**ADDENDUM TO  
INTERIM REMEDIAL ACTION PLAN**

Former Val Strough Chevrolet Site  
327 34<sup>th</sup> Street, Oakland, California  
Fuel Leak Case No. RO0000134

**Re:** **Addendum to Interim Remedial Action Plan**  
Former Val Strough Chevrolet  
327 34<sup>th</sup> Street, Oakland, California  
Site ID #3035, RO #0000134

**PROPOSED ISOC PILOT TEST MONITORING NETWORK**  
 FORMER VAL STROUGH CHEVROLET  
 327 34TH STREET, OAKLAND, CALIFORNIA  
 MAY 2009

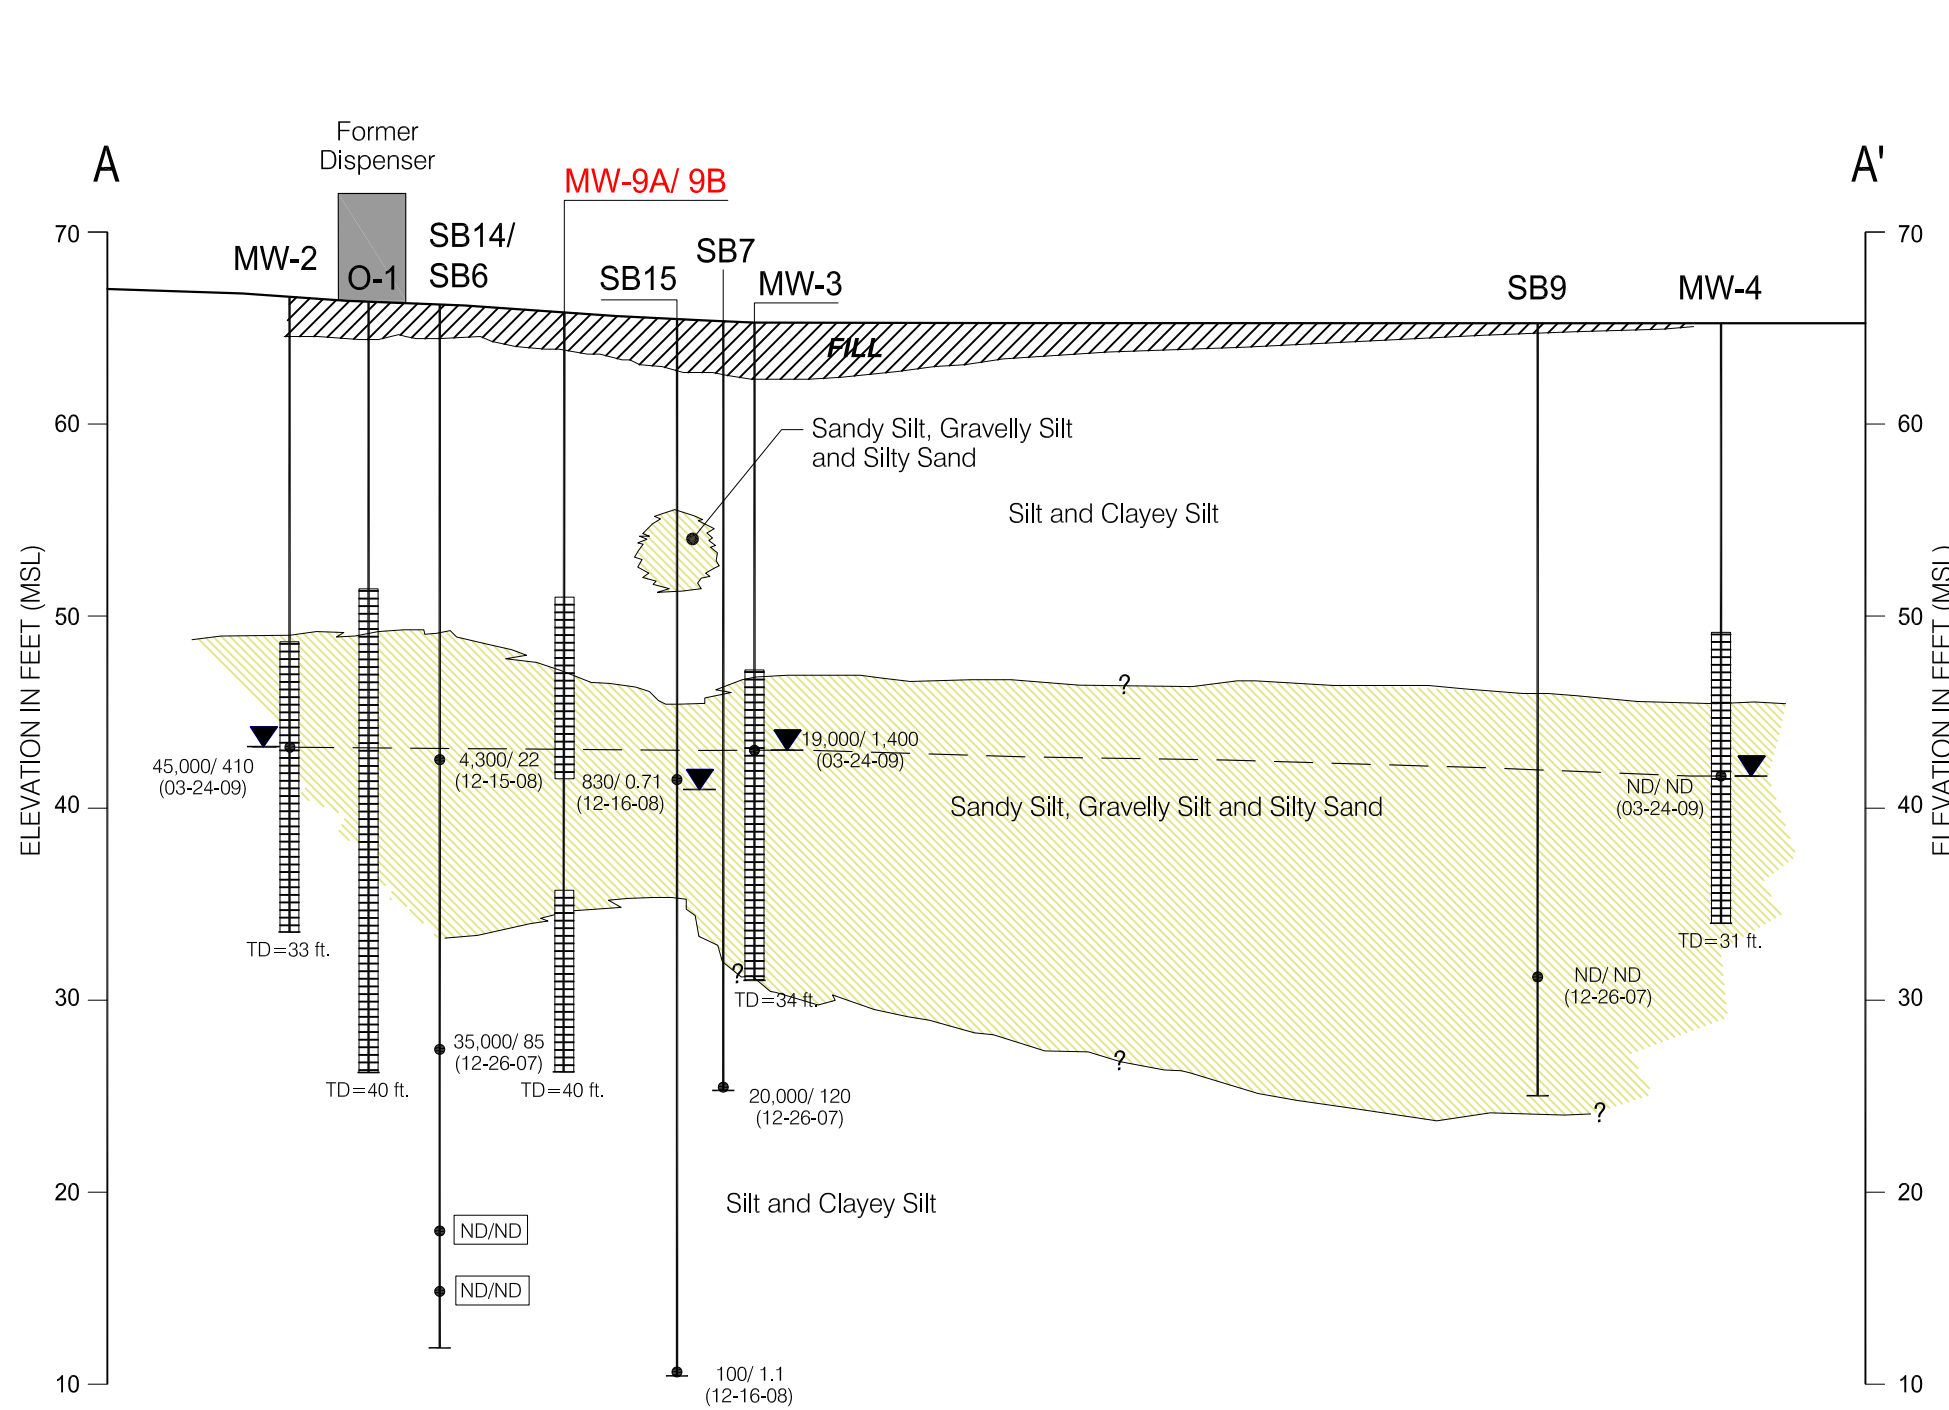
In response to the Alameda County's comments, a nested monitoring well pair to be screened at two distinct depths and identified as MW-9A and MW-9B, is proposed to supplement performance monitoring at MW-2 and MW-3 (see Figure 1.) The location of MW-9A/9B corresponds to the approximate mid-point of the distance between ISOC injection well O-1 and existing downgradient monitoring well MW-3. The pilot test sampling approach for this nested well pair will follow those previously outlined in the IRAP and approved by Alameda County for wells MW-2 and MW-3.

| <b>GEOLOGIC CROSS-SECTION A-A'</b>                                     |                    |                     |

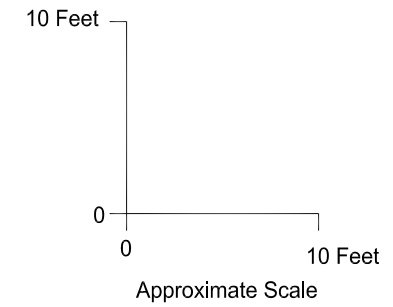
MW-9A will correspond to the shallower of the two screened intervals, occurring from approximately 15 to 25 feet bgs; this screen interval corresponds to the shallower hydrocarbon impacted zones encountered in shallow borings and monitored by well MW-2 screened from 18 to 33 feet bgs (see Figure 2); it also corresponds to the top 10 feet of the well screen in ISOC well O-1, which is screened from 15 to 40 feet bgs (see Figure 2). MW-9B will be screened from 30 to 40 feet bgs, corresponding to the deeper hydrocarbon impacted zones observed in borings; this depth interval also matches the bottom 10 feet of well screen in ISOC well O-1 (see Figure 2). Combined, these two screen intervals will allow for monitoring of the effects of ISOC activities within the entire hydrocarbon-impacted profile encountered during the recent IRAP soil and groundwater field investigation activities.
